HARTZELL PROPELLER INC.
ALERT SERVICE BULLETIN
TRANSMITTAL SHEET
HC-ASB-61-297
Propeller - Hub Inspection

February 12, 2016

This page transmits a revision to Alert Service Bulletin HC-ASB-61-297.

Revision 4 of the Alert Service Bulletin is issued to change the following in the Alert Service Bulletin:

Location of the Lubrication Holes
Figure 1

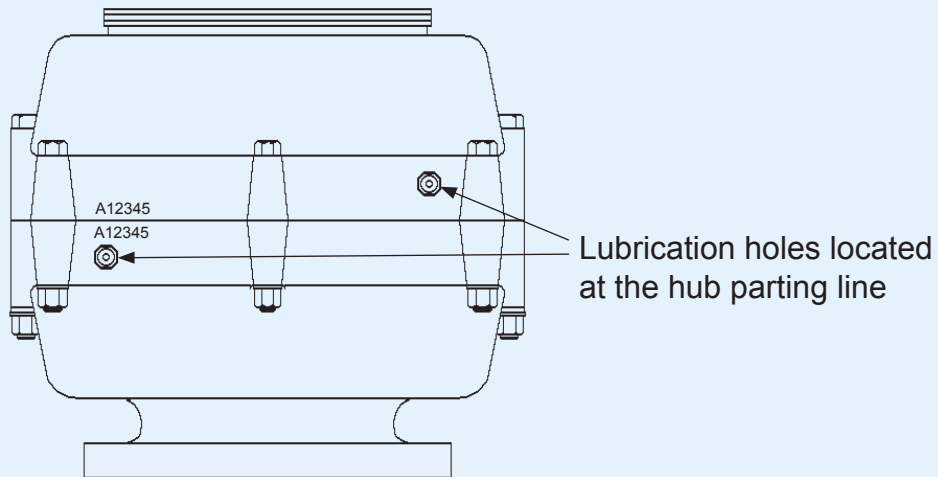
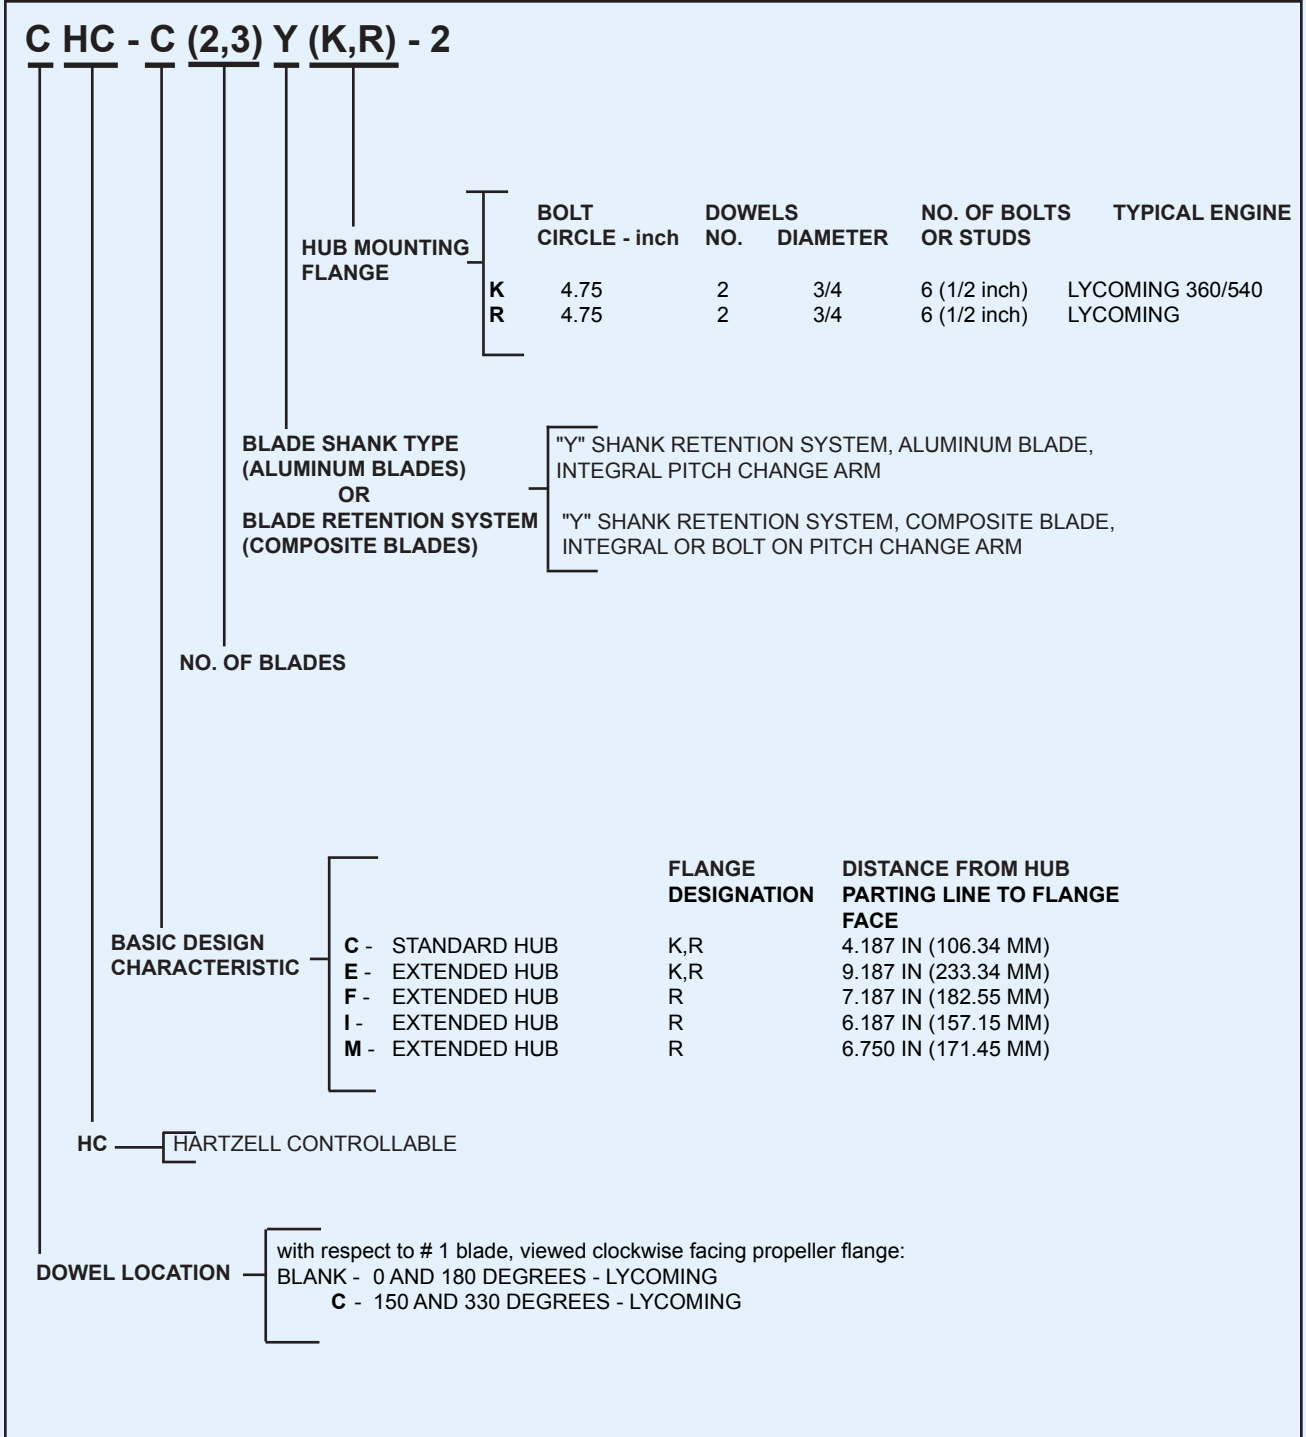
- (1) Hartzell Propeller Inc. left-hand rotating, aluminum hub compact propellers ()HC-() (2,3)Y(K,R)-2 that have the propeller lubrication holes located on the shoulder of the hub blade socket as shown in View A of Figure 1 are affected by this Alert Service Bulletin.
- (a) The affected propellers are installed on Piper Seneca PA-34-200, Piper Seminole PA-44-180, PA-44-180T, or Beech 76 Duchess aircraft with Lycoming 360 series engines.

- (b) During 1983, the propeller lubrication holes were relocated to the hub parting line. Propellers with the lubrication holes located at the hub parting line as shown in View B of Figure 1 are not affected by this Alert Service Bulletin.

Figure 3

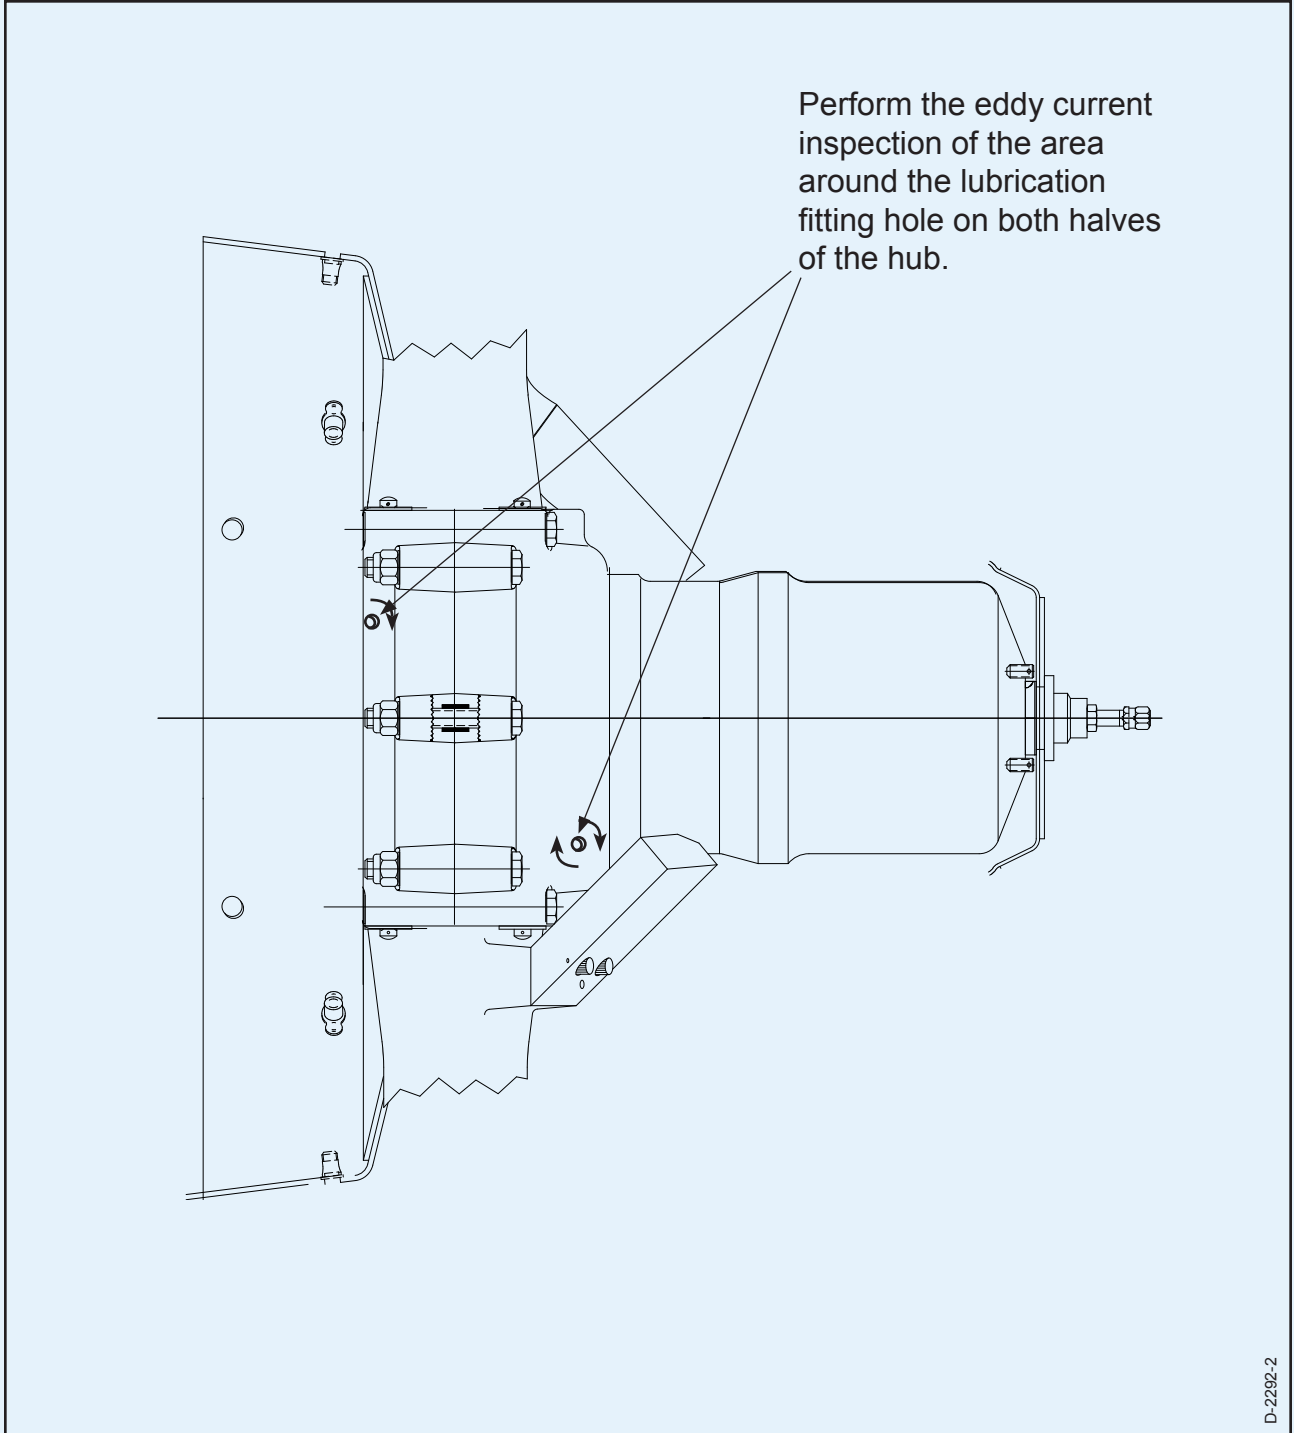
- (4) Before any cleaning, visually examine the hub for cracks in the area around the lubrication holes. Refer to Figure 3.
 - (a) A cracked hub may have traces of grease visible at the location of the crack.
- (5) Clean the surface of the hub in accordance with the Cleaning chapter of Hartzell Propeller Inc. Standard Practices Manual 202A (61-01-02), Volume 1 to remove oil, grease, or other contaminants that may interfere with the efficiency of the eddy current inspection.

- (6) Perform the Aluminum Hub Lubrication Fitting Hole Inspection in accordance with the Eddy Current Inspection chapter of Hartzell Propeller Inc. Standard Practices Manual 202A (61-01-02), Volume 2.
- (7) If a crack indication is found, hub replacement is required before further flight. Report any findings of a cracked hub to the Hartzell Propeller Inc. Propeller Product Support Department.
 - (a) A hub that is removed from an affected propeller because of a crack indication must be retired from service in accordance with the Part Retirement Procedures chapter in Hartzell Propeller Inc. Standard Practices Manual 202A (61-01-02), Volume 6.
